REGIONAL REVIEW NOTICE

ARC REVIEW CODE: R1602111

Name of Proposal: Henry Promenade

HENRY PROMENADE DRI
Henry County
Natural Resources Division Review Comments

DRI SITE PLAN
(DRI #2527)

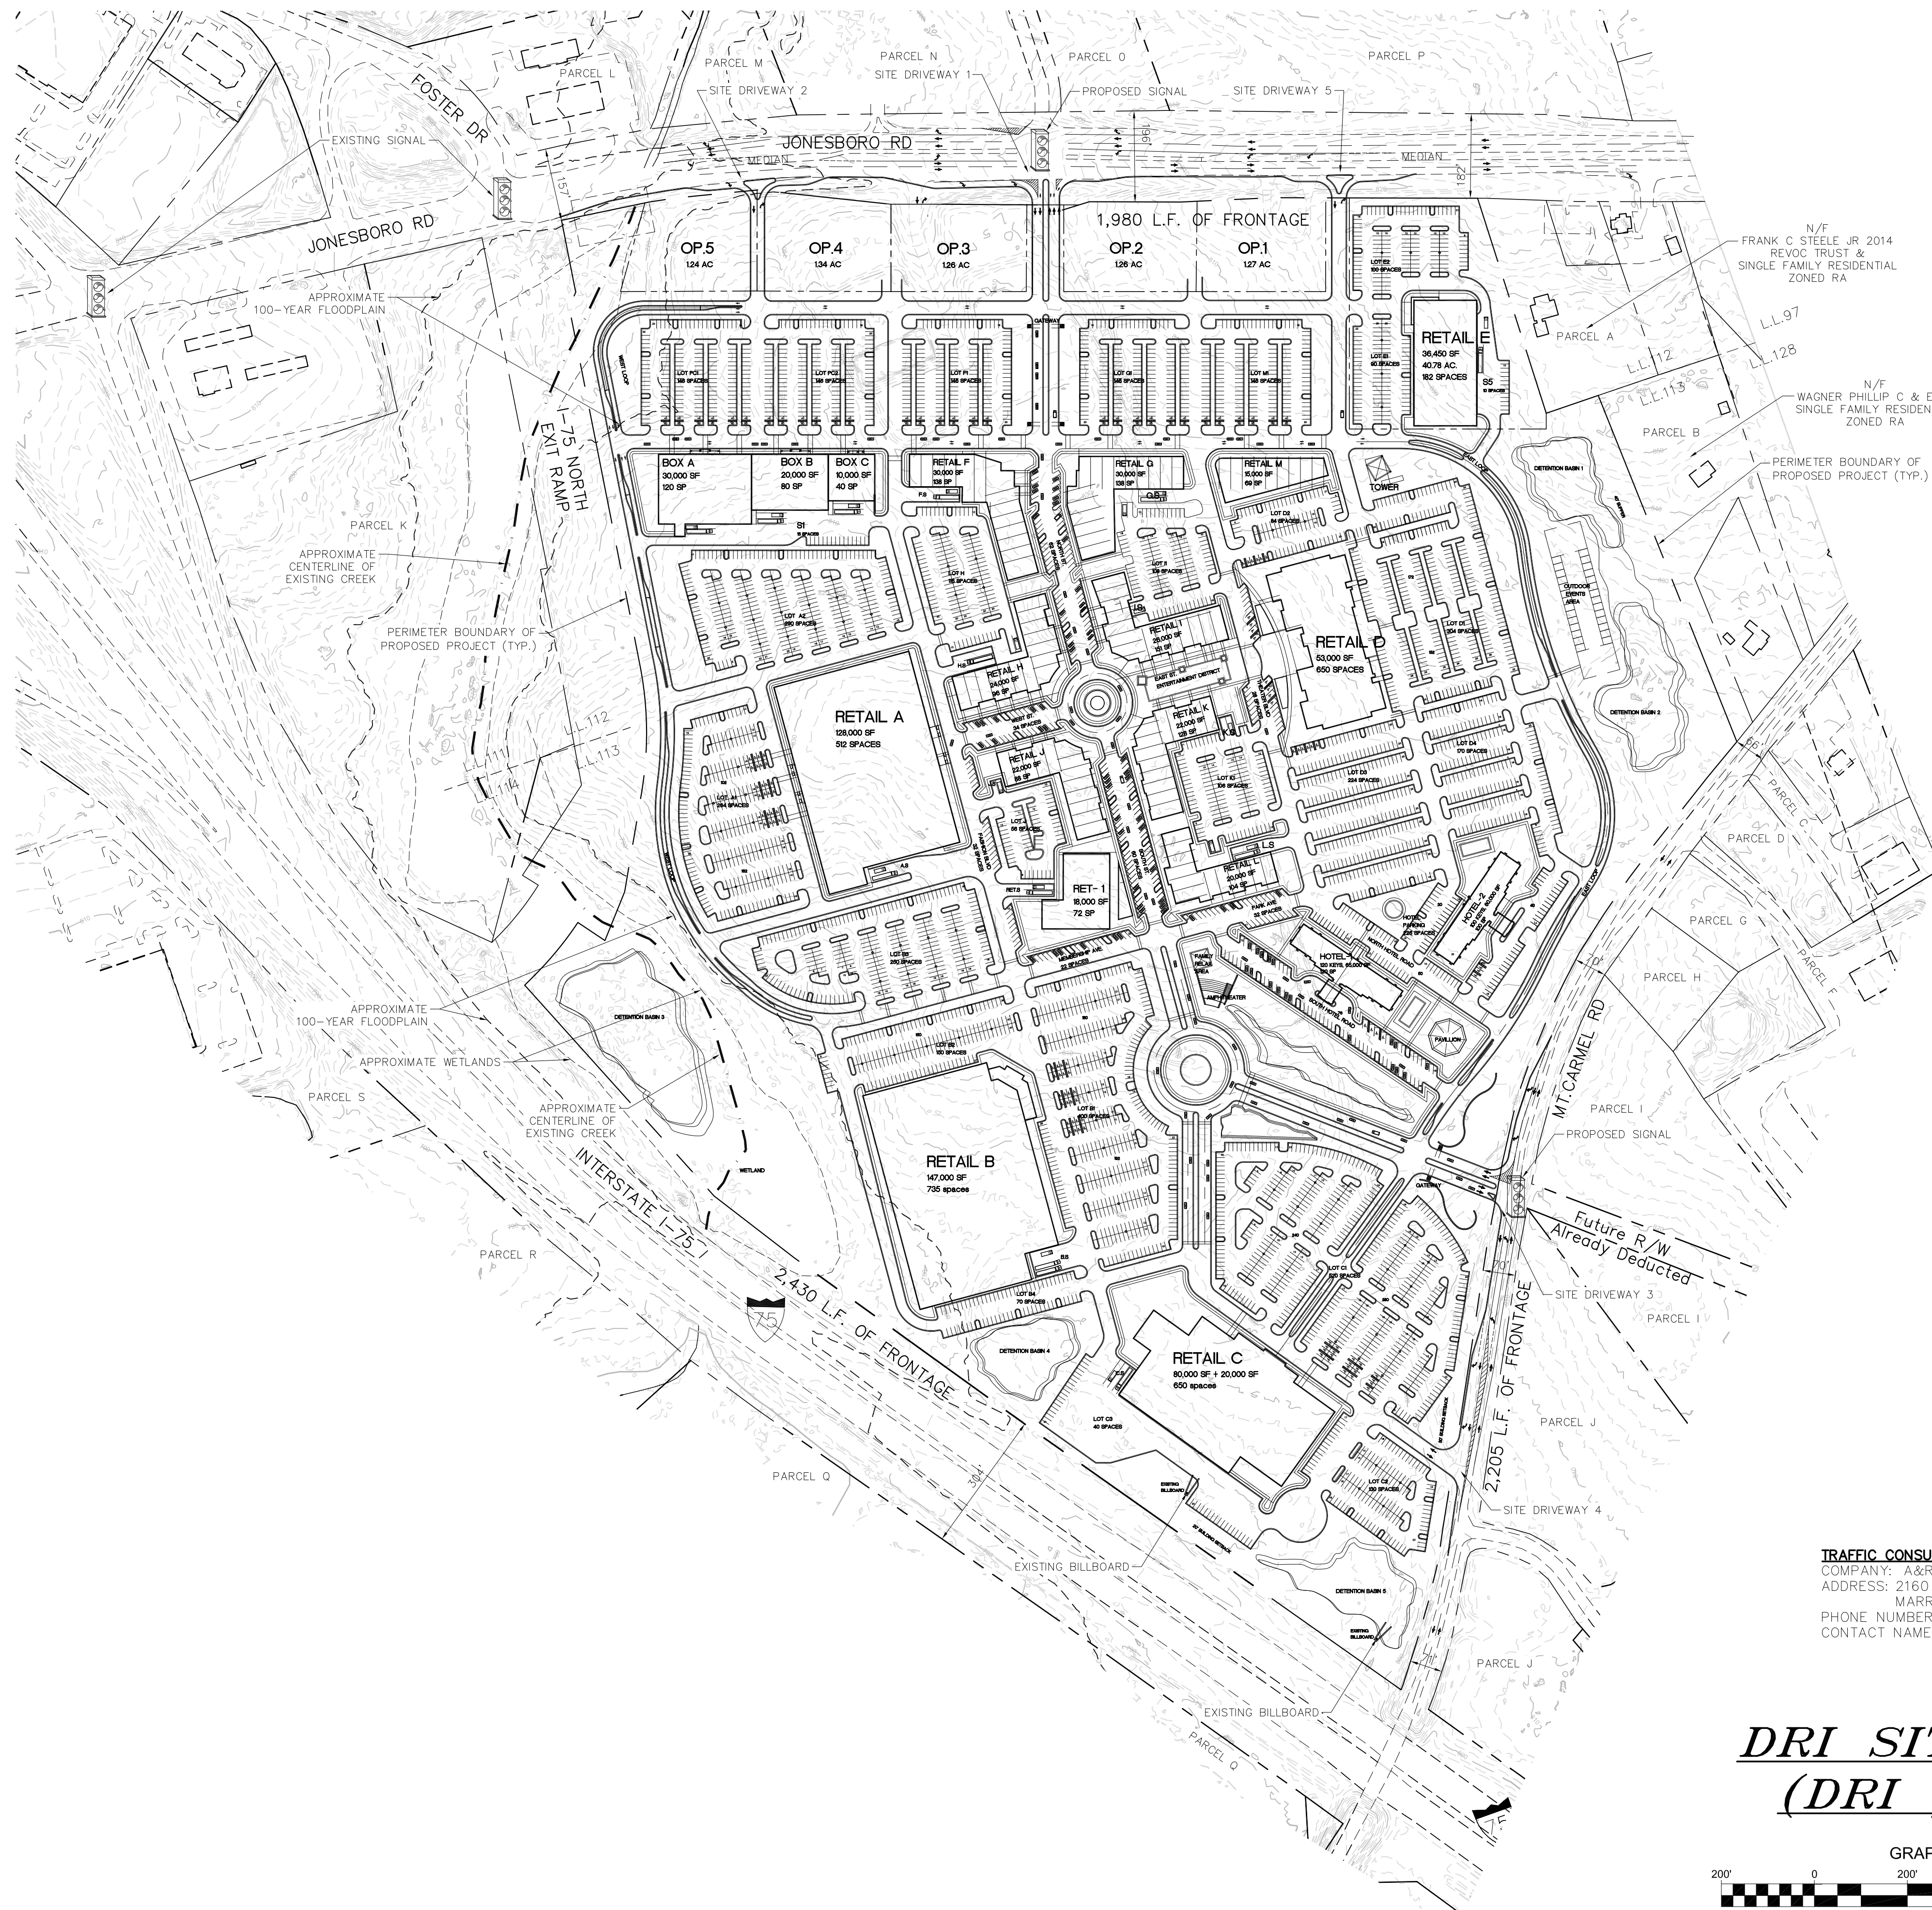
The current plan proposes large surface parking lots on the north side of the site that will be visible along a lengthy section of Jonesboro Road until outparcel development on that side of the site is ultimately realized. While these parking lots serve a purpose, the developer and Henry County should explore strategies for minimizing the visual impact of this parking on the community. The developer and County staff could also use that opportunity to think about strategies for bridging the gap for pedestrians between the rear of the outparcels and the core or "Main Street" section of the development.

The USGS coverage for the project area shows Crittle Creek, a blue-line stream running on or near the western edge of the property. The submitted site plan shows an unidentified stream on the property in two areas near its western edge the property, in the approximate area of the mapped Crittle Creek. No buffers are shown on either be affected stream section. While much of the stream area is outside the indicated perimeter of the project and will be primarily affected by the construction of the I-75 ramp shown on the plans, the section of the stream southeast of the ramp is close to the proposed project limits. This stream section, as well as any others affected by the project development, may be subject to any buffers required by the Henry County Walnut Creek Water Supply Watershed Regulations. In addition, this stream section, as well as any unmapped streams on the property may be subject to the requirements of Henry County's Stream Buffer Ordinance, which include a 50-foot undisturbed buffer and 75-foot impervious surface setback. Any intrusion into the buffers may require a variance from Henry County.

The project plans also show several wetlands areas on the property. These areas will be subject to all applicable US Army COE requirements under Section 404 of the Clean Water Act. These wetland areas as well as all other waters of the state on the property, including the mapped stream, are also subject to the State Erosion and Sedimentation Act requirements, which include buffers.
